Property Alliance Group / Starwood Capital Group Renaissance Site

Residential Building Section 73 Application (141175/JO/2024)

Issue No. 03 23.10.25

5.2 Level 26
S73 Proposal

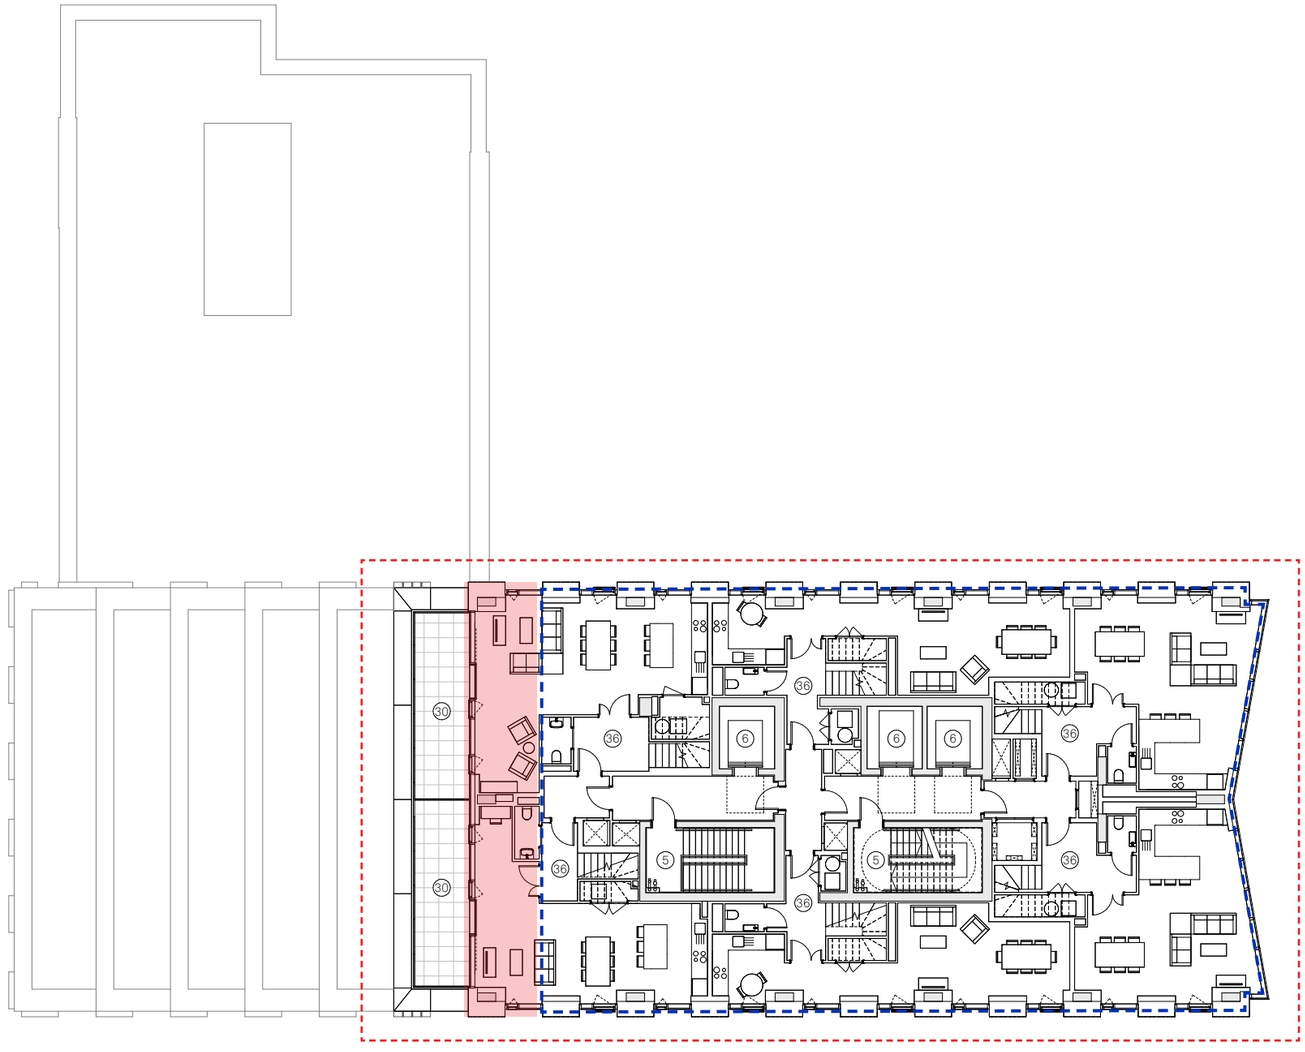
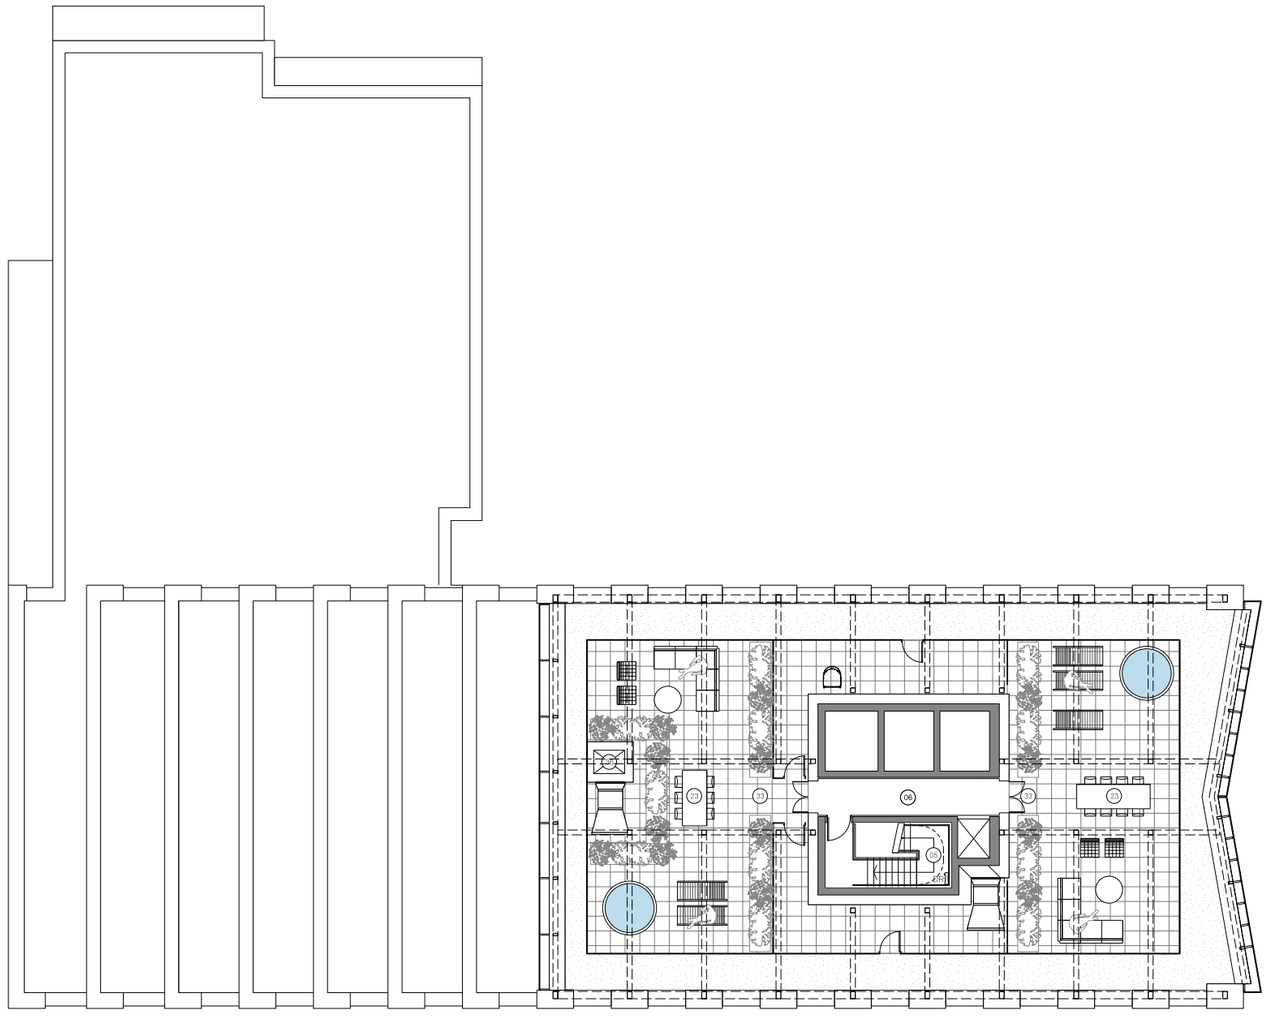
Sept 2024 Amendments:
(141175/JO/2024)

- Fire-fighting lobby added to all floors with an +1 additional stair and associated fire fighting lobbies.
- New duplex units proposed with entry at level 26 and upper floor accommodation at level 27 connected via an internal stair.
- Internal floor plate extended into previous / consented external terrace area. Therefore the 26th floor massing increased where identified.
- Scale, massing and elevation amendments proposed where the floorplate is extended

5.2 Level 27
S73 Proposal

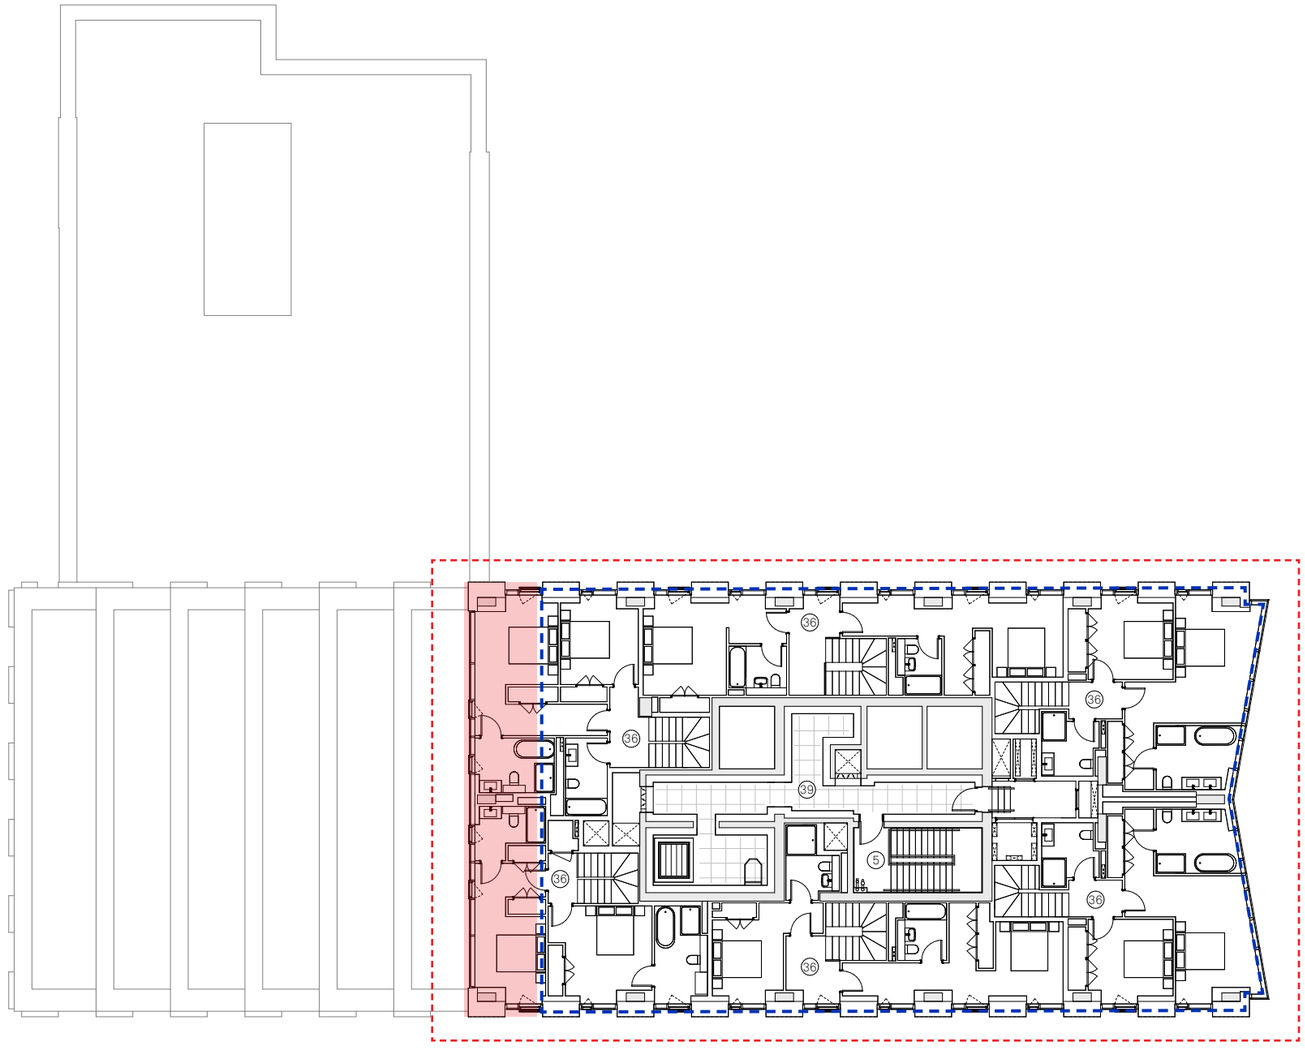
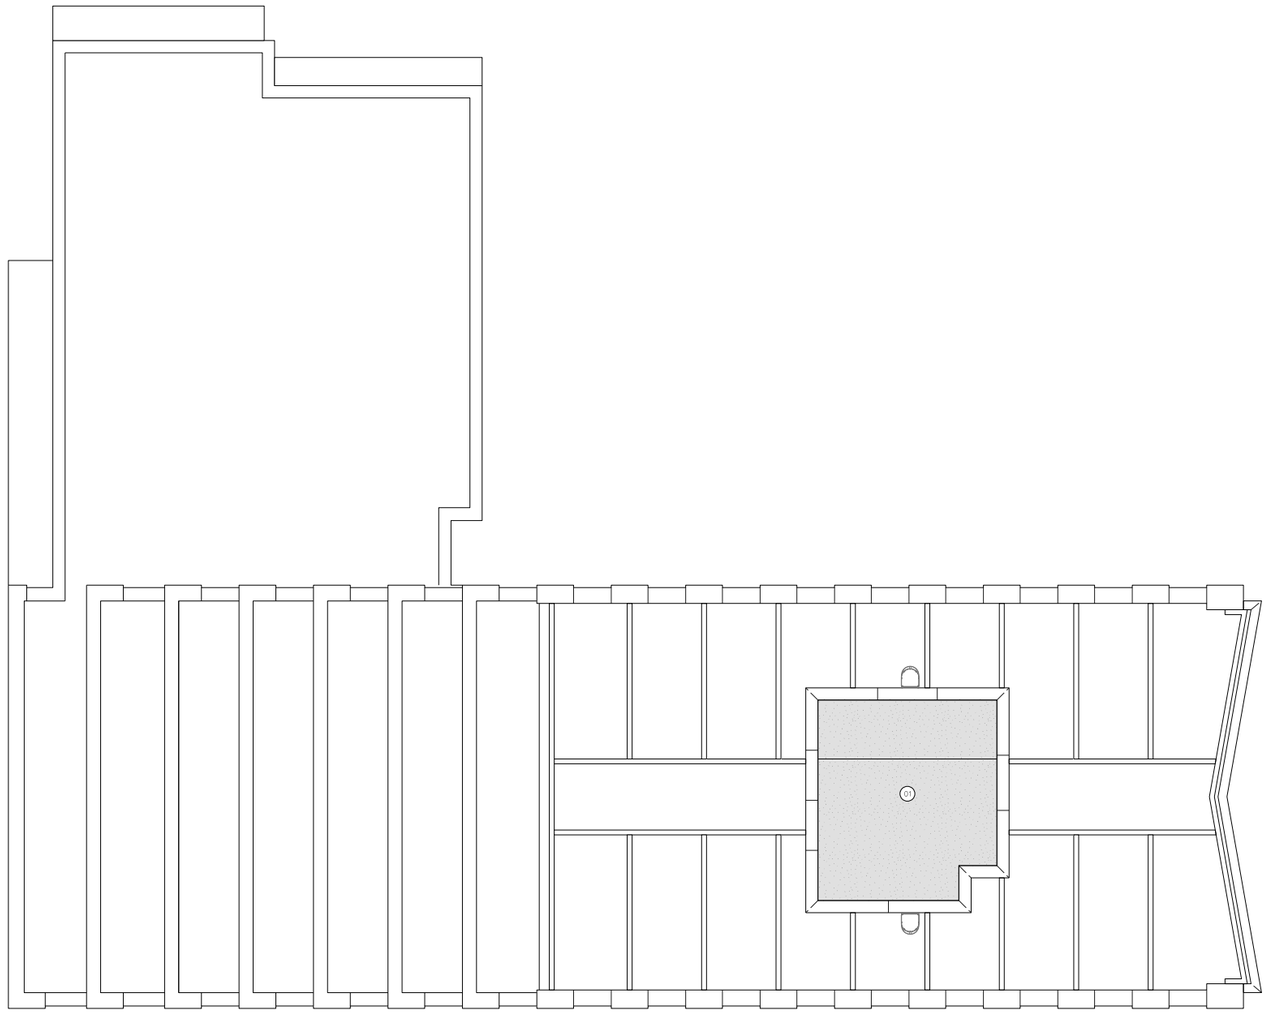
Sept 2024 Amendments:
(141175/JO/2024)

- Fire-fighting lobby added to all floors with an +1 additional stair and associated fire fighting lobbies.
- New duplex upper floor accommodation proposed at level 27.
- Internal floor plate extended into previous / consented external terrace area. Therefore the 27th floor massing increased where identified.
- Scale, massing and elevation amendments proposed where the floorplate is extended.

5.2 Roof
S73 Proposal

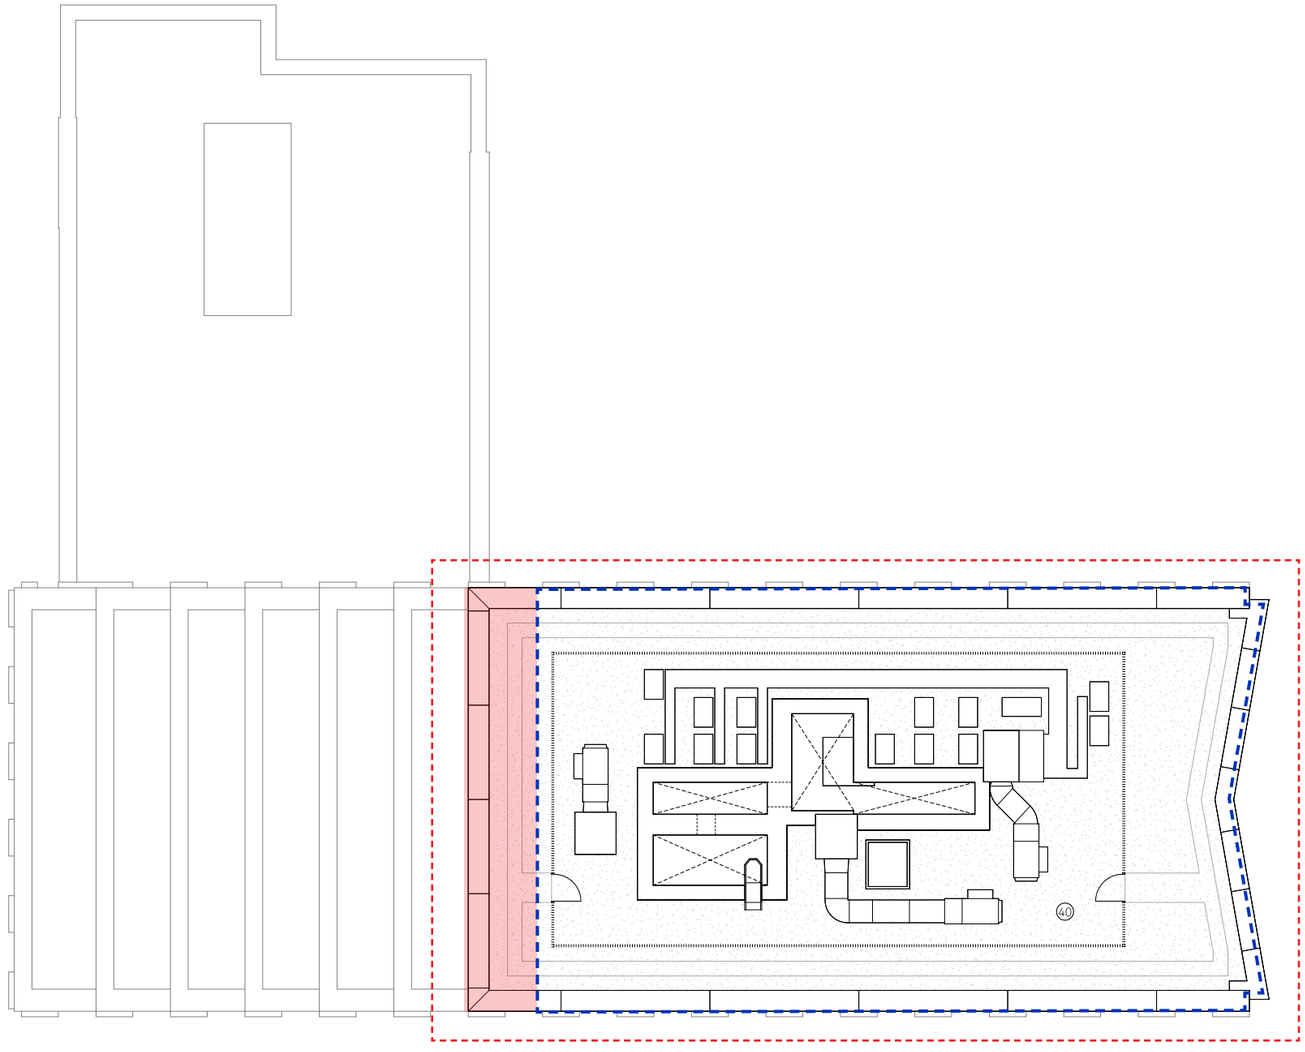
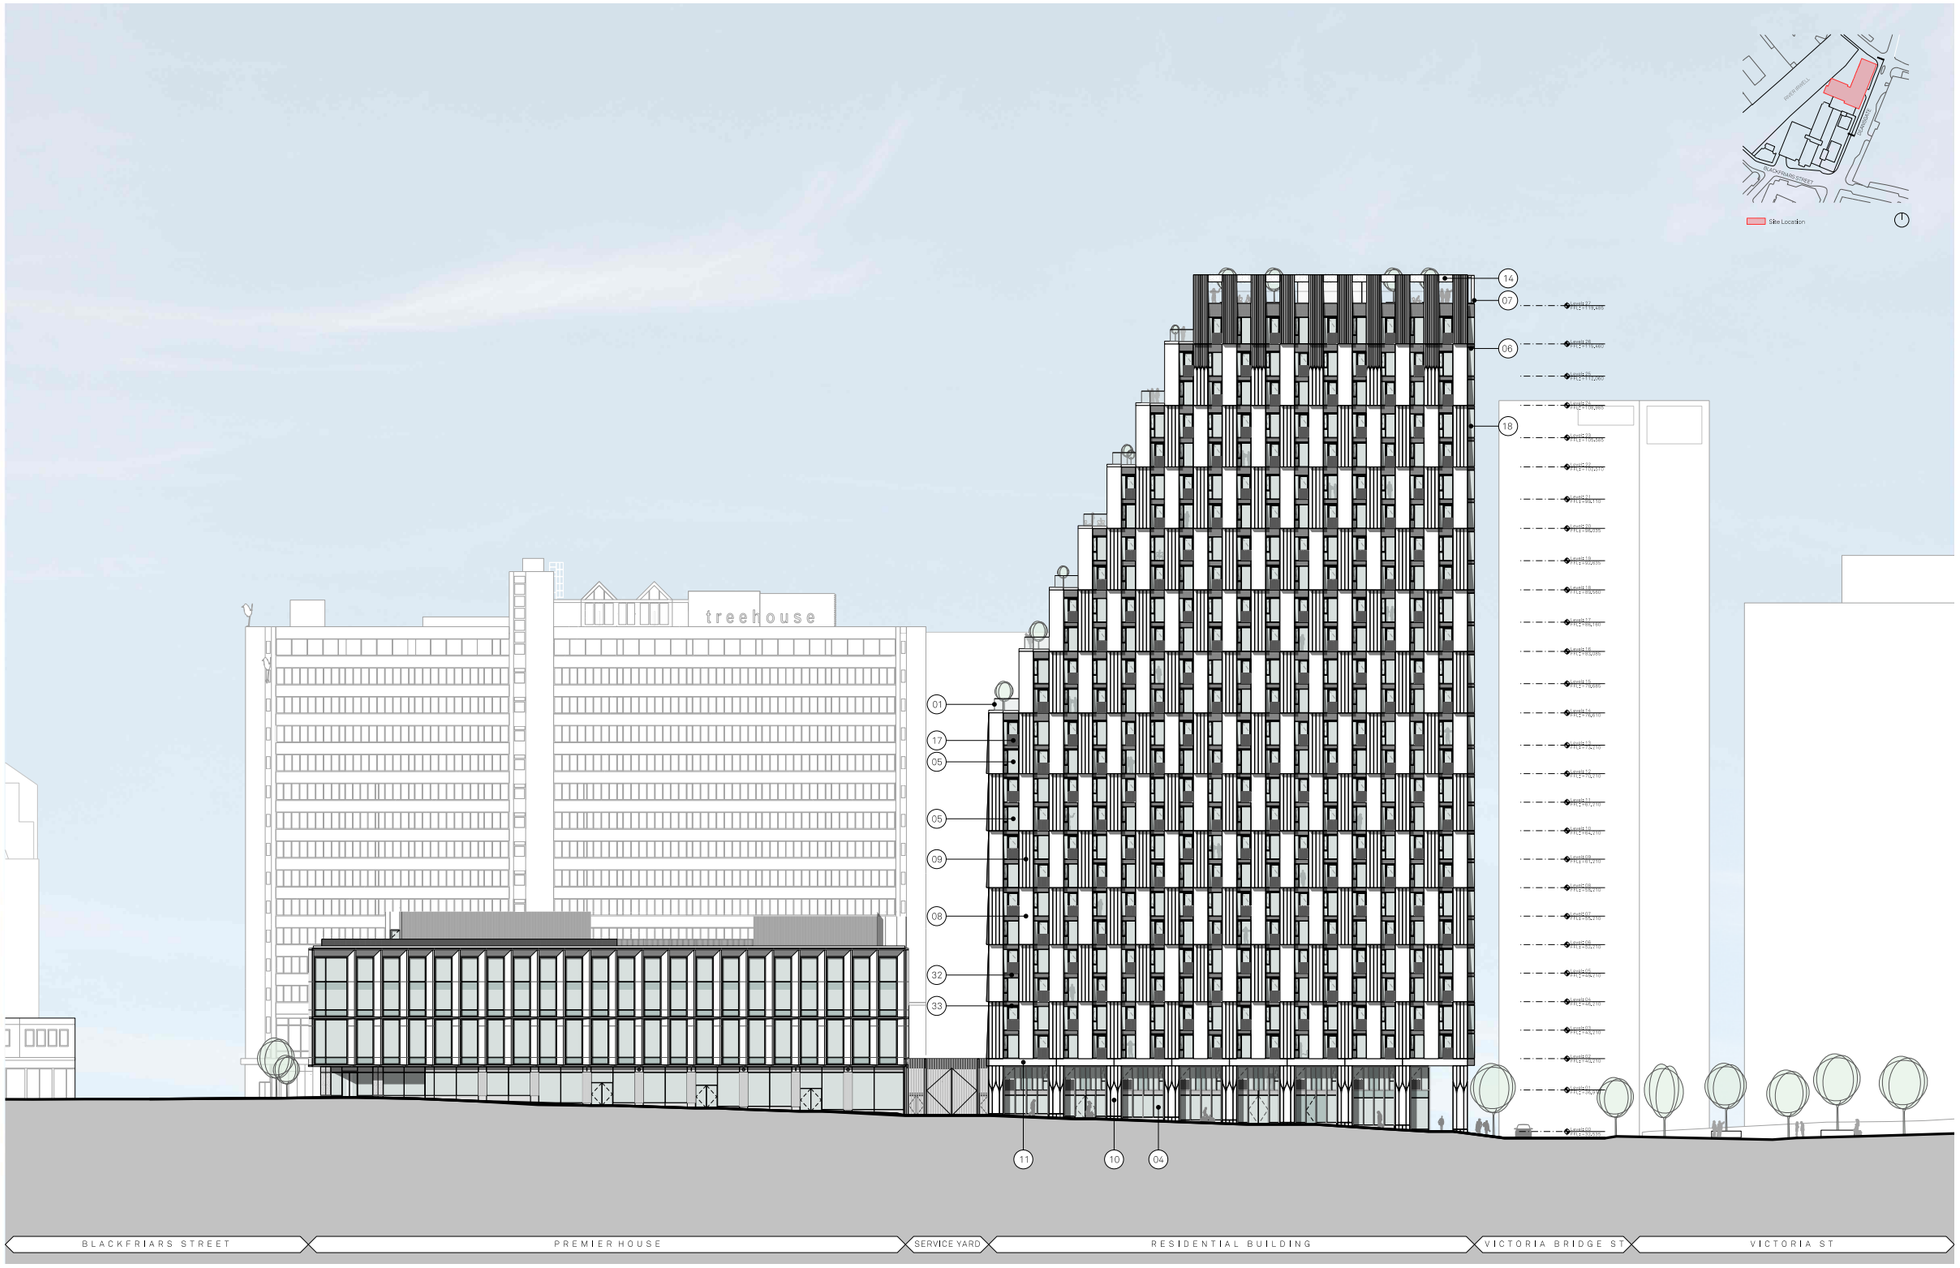
Current Proposed Amendments 2025:
- Plant space added with metal fins enclosure to conceal plant equipment. The plant enclosure is recessed from the main facade to mitigate view impact from street level.
